CITY OF ALBUQUERQUE

Re: Commercial Apartment Building, Phase 1
4419 4th St. NW
Traffic Circulation Layout
Engineer's/Architect's Stamp dated 4-18-16 (G14-D066)

DRAINAGE AND TRANSPORTATION INFORMATION SHEET (REV 10/2015)

COMMERCIAL & APARTMENT BUILDING 4419 4TH ST., NW., ALBUQUERQUE, NM 87107 TRAFFIC CIRCULATION LAYOUT			
DRAWING:	DRAWN BY:	DATE:	SHEET #
201601-ST.DWG	SH-B	04-11-2016	C1 OF 6

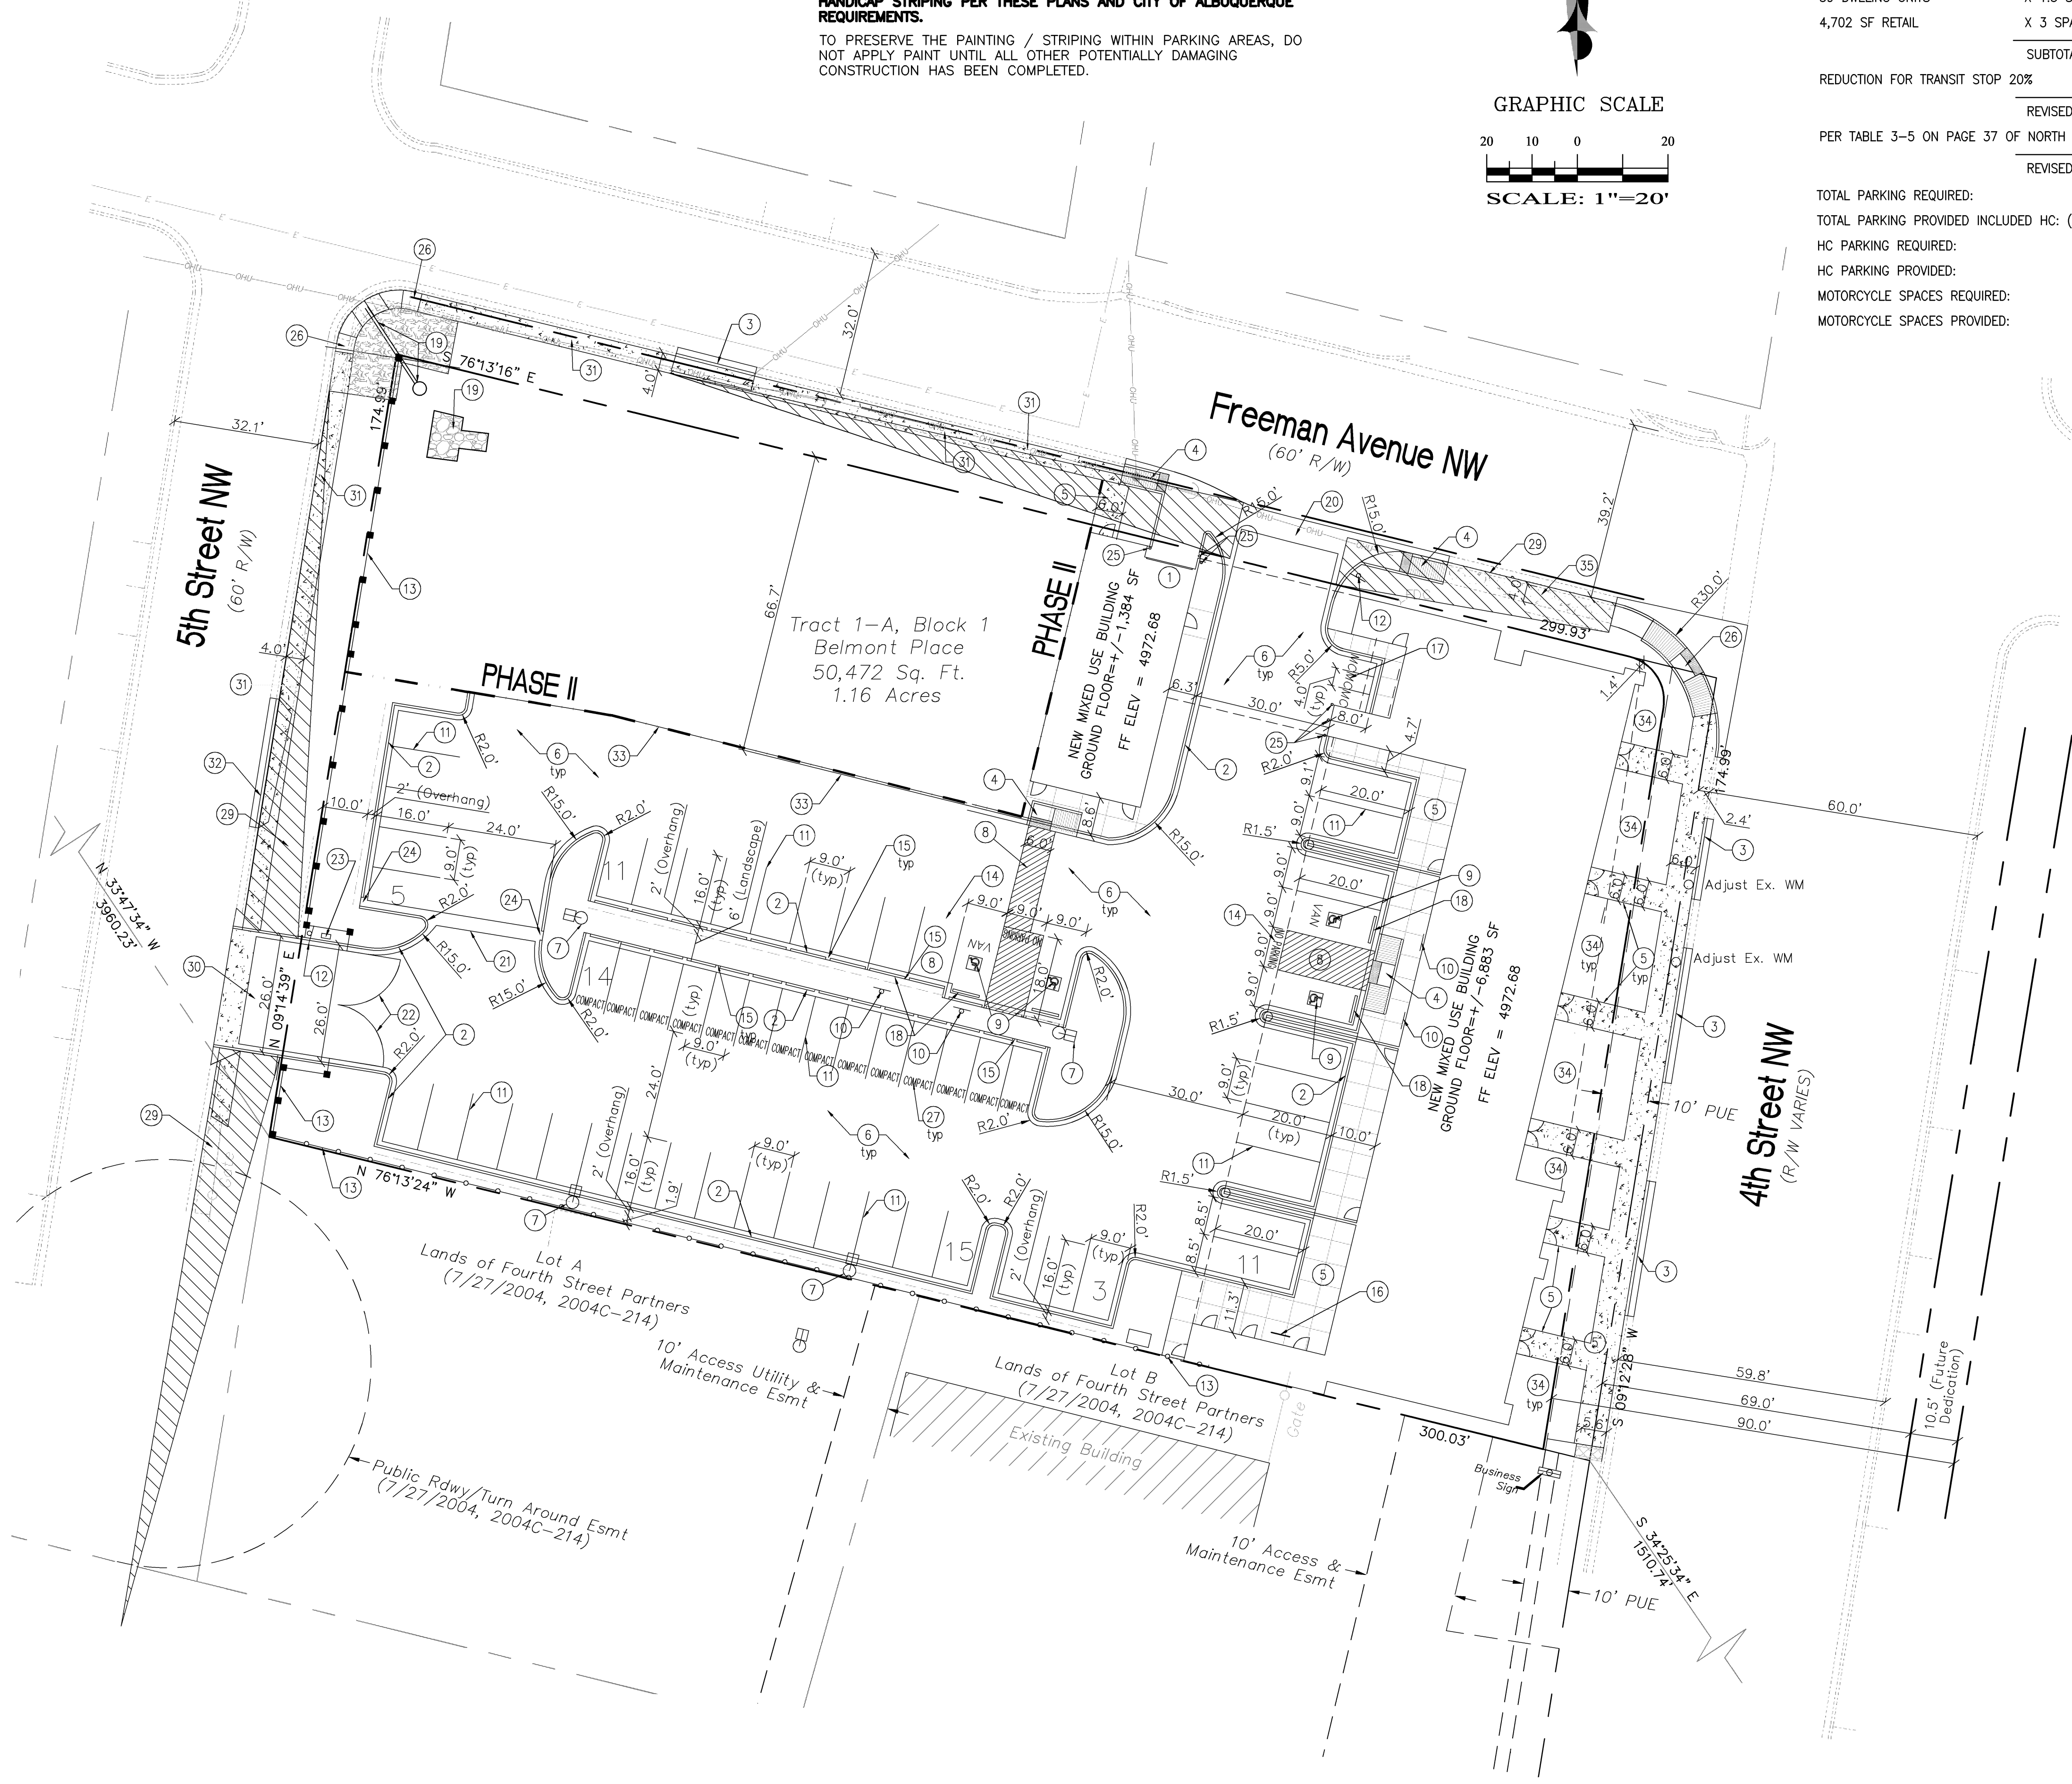
The TCL submittal received 4-13-16 is approved for Building Permit. A copy of the stamped and signed plan will be needed for each of the building permit plans. Please keep the original to be used for certification of the site for final C.O. for Transportation.

When the site construction is completed and a Certificate of Occupancy (C.O.) is requested, use the original City stamped approved TCL for certification. Redline any minor changes and adjustments that were made in the field. A NM registered architect or engineer must stamp, sign, and date the certification TCL along with indicating that the development was built in "substantial compliance" with the TCL. Submit this certification TCL with a completed Drainage and Transportation Information Sheet to front counter personnel for log in and evaluation by Transportation.
